Application Number: 10/783,812
Filing Date: February 20, 2004
Appellant(s): GAMMON, BARRY

EXAMINER'S ANSWER

This is in response to the appeal brief filed January 09, 2006 appealing from the Office action mailed July 21, 2005.

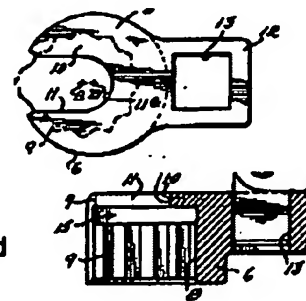
Claims 1 and 2 (as best understood) stand rejected under 35 U.S.C. 102(b) as being anticipated by Johnson, US Patent No. 2,715,347.

Johnson discloses all the limitations, i.e., a socket having a center line (B) and a perimeter (Fig. 3), first face (bottom face as shown in Figs. 2 and 4), an opposite second face, and a receiving slot extending from the first face towards the second including a receiving region (8) adjacent to the first face (first face separated from the second face by web 10) having a center line (A) offset from (B) and includes a step (defined by 10 or 15) against which the connection element rests during rotation of the socket body, and wherein the second face includes a port (13) that does not extend to the first face, having a center line that is not in alignment with the socket body positioned within the perimeter of the socket body.

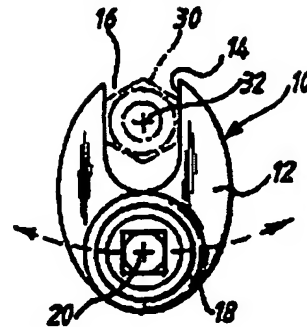
Claims 1-6 (as best understood) are rejected under 35 U.S.C. 103(a) as being unpatentable over Higgins (GB 2 266 257) in view Farnan et al.

Higgins meets all the limitations of the claim 1, i.e., a socket having a center line and a perimeter, first face and an opposite second face, and a receiving slot extending from the first face towards the second including a receiving region adjacent to the first face having a center line that is not in alignment with the centerline of the socket body (Fig. 1) and wherein the second face includes a port (24) that does not extend to the first face of the socket body, the port having a center line that is not in alignment with the center line of the socket body, except for a step against which the connection element rests during rotation of the socket body. Farnan et al. teaches stepped polygonal configurations having wing slots. It would have been obvious to one of ordinary skill in the art, at the time the invention was made, to modify the invention of Higgins with the polygonal stepped configuration and wing slots as taught by Farnan et al. to adapt the tool for driving different sized fasteners and fasteners having wings.

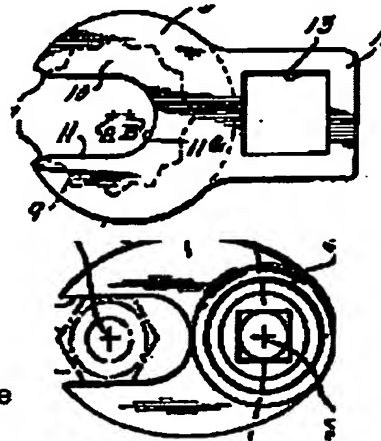
In response to the argument against anticipation, Appellant argues that the port in Johnson is not part of the body, and states that the port is in the handle section and not the head proper or box portion 5 of the wench head. This argument fails to indicate which part of the claim limitations are not met. Whether Johnson discloses an inferior design or not does not further limit the tool as claimed. At best it appears, Appellant reads more into the "body" than recited. Claim recite for the body to have a center line and a perimeter, a first face, an opposing second face and a receiving slot extending from the first face to the second face...the socket body includes a step against which the workpiece rests...and wherein the socket drive port is positioned within the perimeter of the socket body and does not extend above the first face.

Lackign structural limitation and relationship and or clear definitions of the elements, the socket of Johnson meets the "body" as recited. The fact that the port is located on "handle receiving shank" as argued by Appellant, does not exclude the reference, as it appears that Appellant is arguing for the shape of the body, without such limitations recited in the claim. In fact Higgins was cited to emphasis this point, that the port is part of the body.

With regards to the argument that the driver port of Johnson is not the same, because the port in Johnson is through and through, again Appellant is arguing features not recited in the claim. The limitation regarding the port is that it does not extend through to the first face, which is met by the port as disclosed by Johnson. The second face of the socket (the upper surface as

shown here) includes a port (13), which does not extend to the first surface (the lower surface shown here).

FIG. 2.

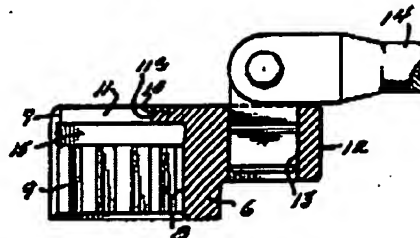
A socket for rotatably loosening or tightening a connection element, the socket comprising a socket body having a centerline (the body has an infinite number of "centerlines", e.g., B which is a lateral center on a line dividing the body symmetrically in half widthwise, or a centerline on a longitudinal line which would be

offset from B towards the port, here B was noted by the Examiner to meet this limitation), a first face (lower surface of cavity as shown here), an opposing

second face (upper surface) and a receiving slot (cavity 8) extending from the first face to the

second face, wherein the receiving slot includes a receiving region adjacent to the first face for

receiving and capturing therein the connection element, the receiving region having a centerline (A) that is not in alignment with the centerline of the socket body (e.g., Fig. 3) and includes step (defined by 10 or 15) against which the connection element rests during rotation of the socket body, wherein the second face includes a socket driver port (13) therein that does not extend through to the first face of the socket body (as shown here, extends to a third face but not the first), the socket driver port having a centerline that is not in alignment with the centerline of the socket body (e.g., Fig. 3, shown here), and wherein the socket driver port is positioned within the perimeter of the socket body and does not extend above the first face (e.g. Fig. 2).
